FAQ Number: 09-0056

FAQ Title: Radioactive Release Transition

Submittal Date: July 22, 2010

Submitter Contact: NRC (Charles Moulton)

Figure 4.3.4.1

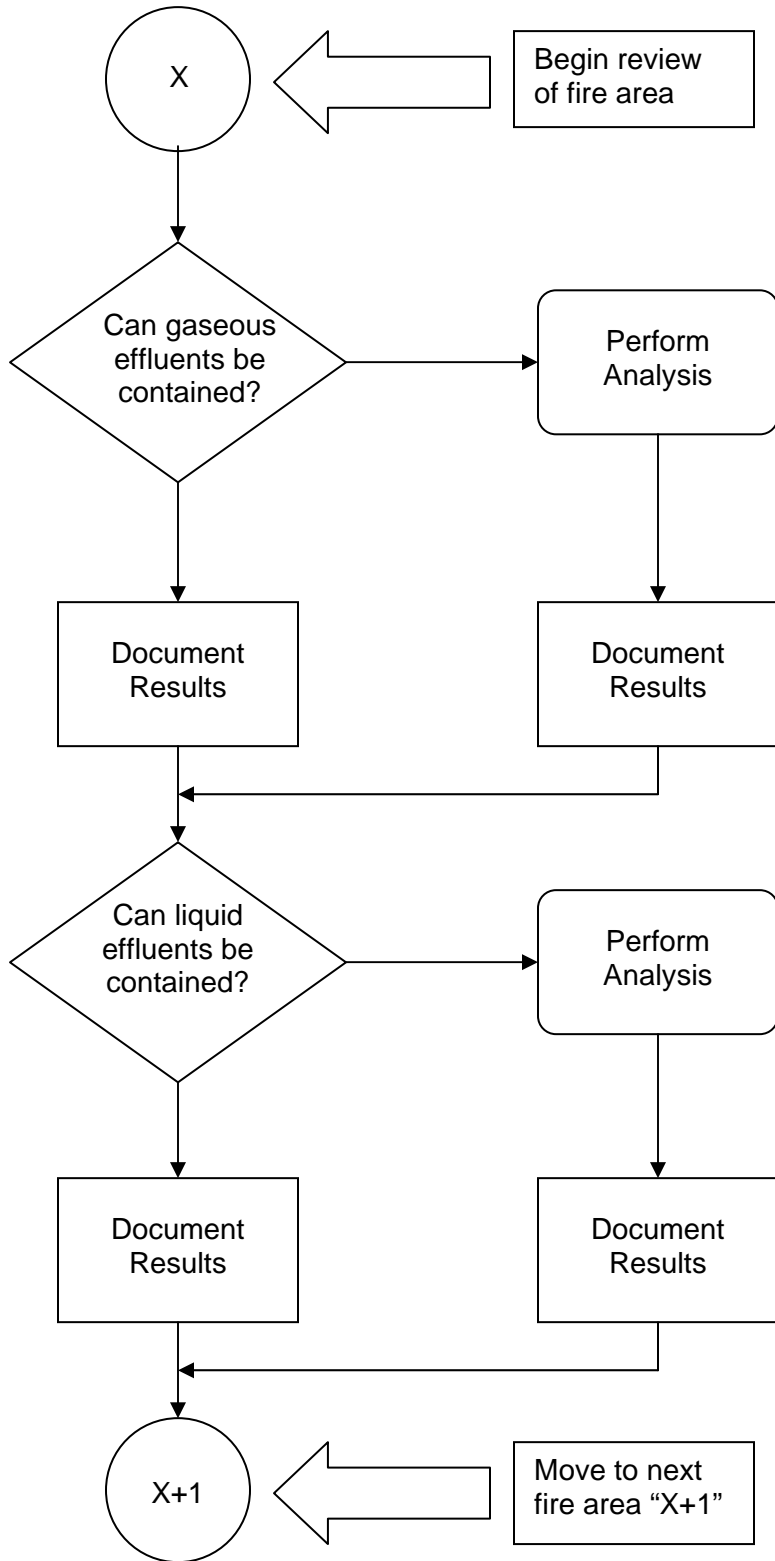
- Review fire pre-plans and fire brigade training materials to identify FPP elements (e.g., systems / components / procedural control actions / flow paths, etc.) that are being credited to meet the radioactive release goals, objectives, and performance criteria during all plant operating modes, including full power and non-power conditions.
- Review engineering controls for to ensure containment of gaseous and liquid effluents (e.g., smoke and fire fighting agents). This review shall cover all plant operating modes (including full power and non-power conditions). Otherwise, provide a bounding analysis, quantitative analysis, or other analysis that demonstrates that the limitations for radioactive effluent release specified in the unit's Technical Specifications are met. (See Figure 4.3.4.1)
